Re: Edwards Aquifer, Comal County
NAME OF PROJECT: Prodigy Learning Center; Located at the SW corner of SH 46 and
Hunters Village Rd., New Braunfels, Texas
TYPE OF PLAN: Request for the Approval of a Water Pollution Abatement Plan (WPAP);
30 Texas Administrative Code (TAC) Chapter 213 Edwards Aquifer
San Antonio File No. 1964.08; Investigation No. 849289; Regulated Entity No.
RN105980205

RE: Prodigy Learning Center Water Pollution Abatement Plan Application

This letter is in response to the fax received 09/07/2010 TCEQ as it pertains to the Prodigy Learning Center Water Pollution Abatement Plan Application. The comments received are in italics and our responses are in bold.

WATER POLLUTION ABATEMENT PLAN
FOR
PRODIGY LEARNING CENTER

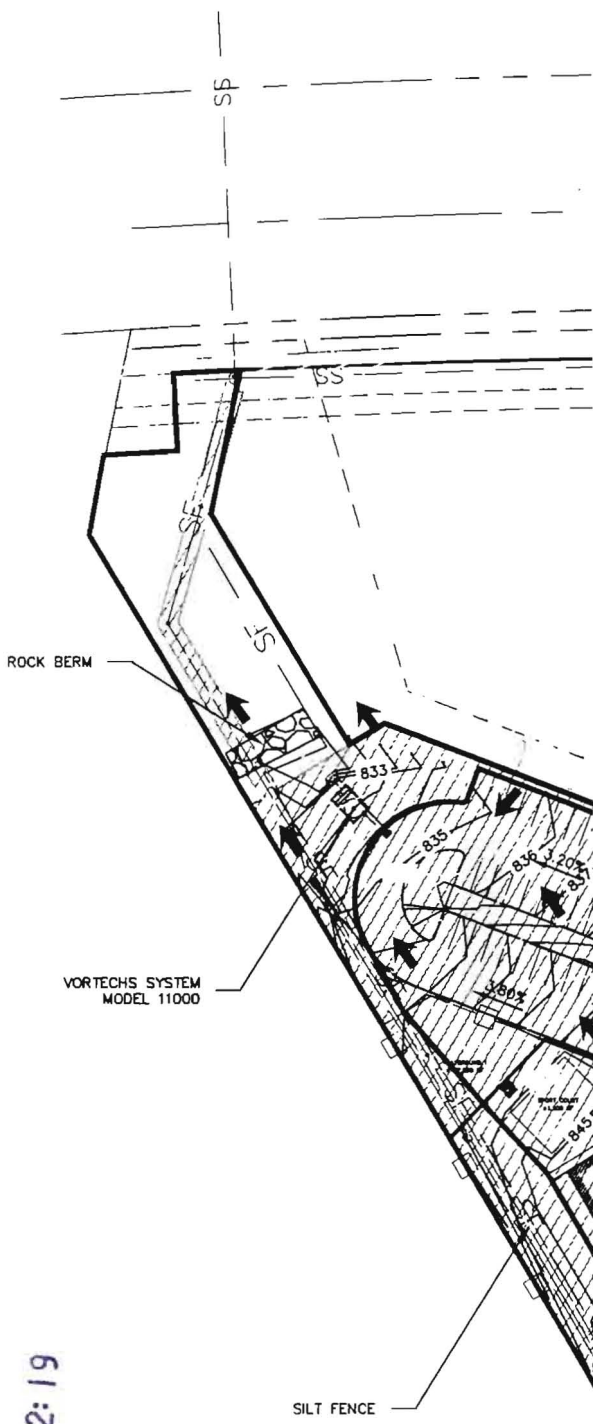
7. *On the Grading Plan exhibit, See sheet 4 of 7, the cross section of the Vegetative Filter Strip indicates the ribbon curve is higher than the roadway surface.*
- a. *Will this raised ribbon curb result in the storm water being channelized and flowing along the curb (towards the building), around the filter strip? Or will the small elevation difference of the curb still allow flow over the curb?*

- b. *According to the Edward Aquifer Technical Guidance Manual, RG-348, "the top edge of the filter strip along pavement will be designed to avoid the situation where runoff would travel along the top of the filter strip, rather than through it. "Based upon the cross section and the 0.1' height difference from the top of the ribbon curb to the top of filter strip, it appears storm water will flow over the filter strip instead of through the strip. Revise the design of the filter strip, as necessary, or provide additional details to clarify the situation.*

The vegetative filter strip will be constructed to allow stormwater to flow through it and not over it.
